Work Order ID **110381**

Item Name: Strut Bracket

APICAL INDUSTRIES, INC.	ENGINEERING CHANGE NOTICE NO. 03985			SHEET 1 OF 2	
	DWG NO. 647.0100	REV: A	PREPARED BY J. BECKER	DATE: 7/15/13	EFFECT ON DWG ☐ INC. ☒ UNINC.
	DWG TITLE: SHEET METAL				
	APPROVED BY: ENGR. <i>[Signature]</i>	MFG <i>[Signature]</i>	QC <i>[Signature]</i>	EFF. NEXT ORDER	
TRANSACTION CODES (TC): A-ADD C-CREATE R-REVISE D-DELETE	REASON: REVISED NOTE 2. ADDED 647.0117

SHEET 1, ZONE D1 IS:

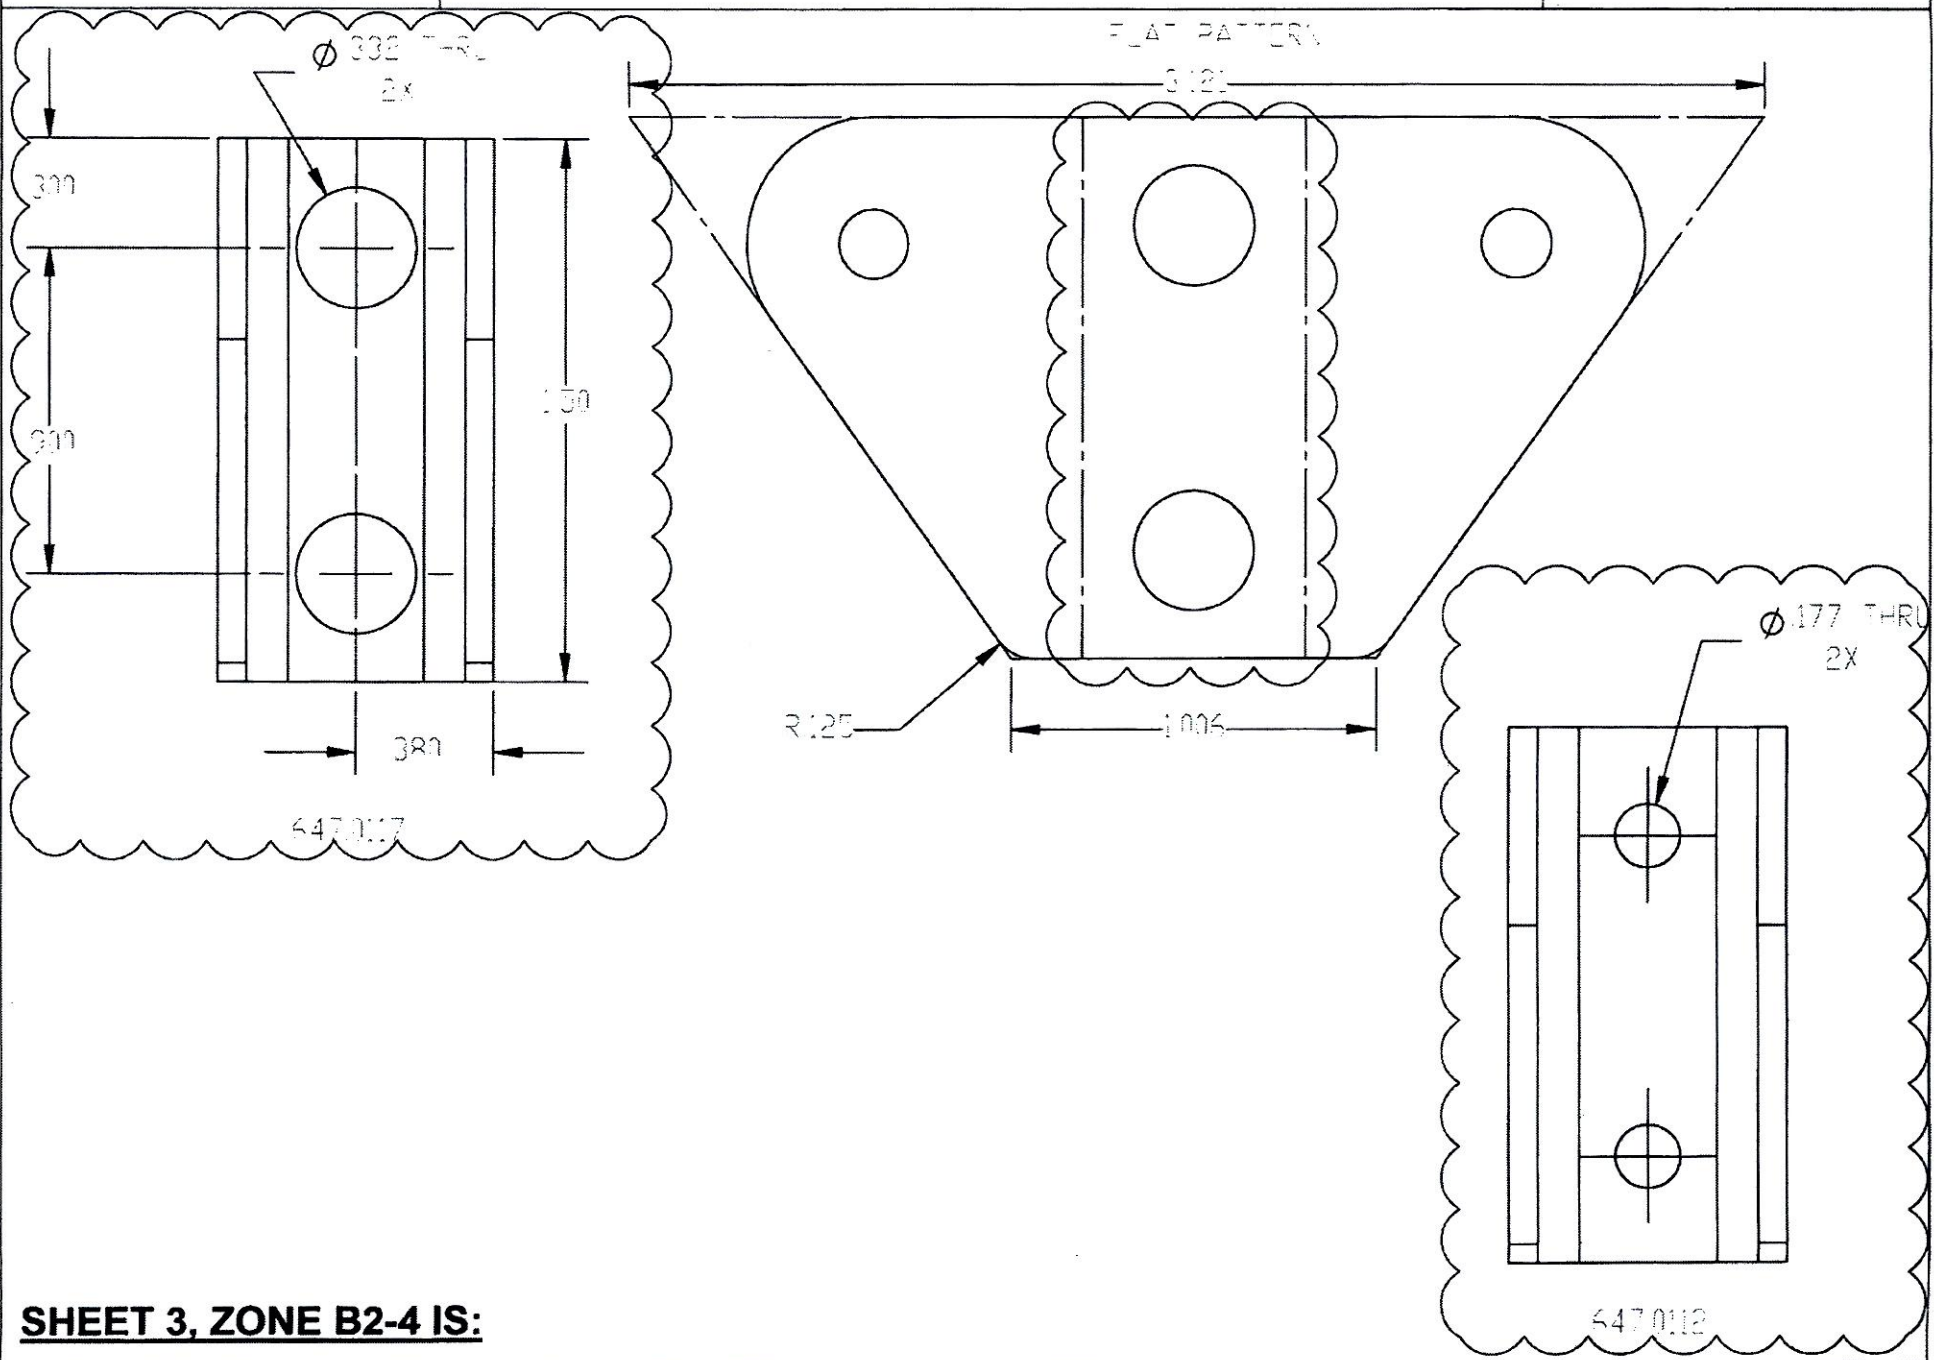
- 1 MATERIAL: ALUMINUM 2024-T3 PER AMS-QQ-A-250/4.
- 2 FINISH: IAW MPP-172 ANODIZE IAW SECTION 2.1,
PRETREATMENT IAW SECTION 3.1
AND PRIMER IAW SECTION 4.1.
3. DEBURR AND BREAK ALL SHARP EDGES.
4. IDENTIFY IAW MPP-120.
- 5 MATERIAL: 304 SS IAW AMS 5643.
- 6 FINISH: PRIME IAW MIL-P-23377J TYPE I CLASS N.
- 7 OTHER DIMENSIONS SAME AS 647.0112.

C	647.0117		STRUT BRACKET	△	△
F/NTC	PART NUMBER		DESCRIPTION	MATERIAL	SPECIFICATION
DOCUMENTS EFFECTED:			CHANGE CATEGORY	DER REVIEW REQUIRED	
☐ MDL ☐ INSTALL INSTRUCTIONS ☐ ICA ☐ FMS ☐ BOM			☐ MAJOR ☒ MINOR	☐ YES ☒ NO
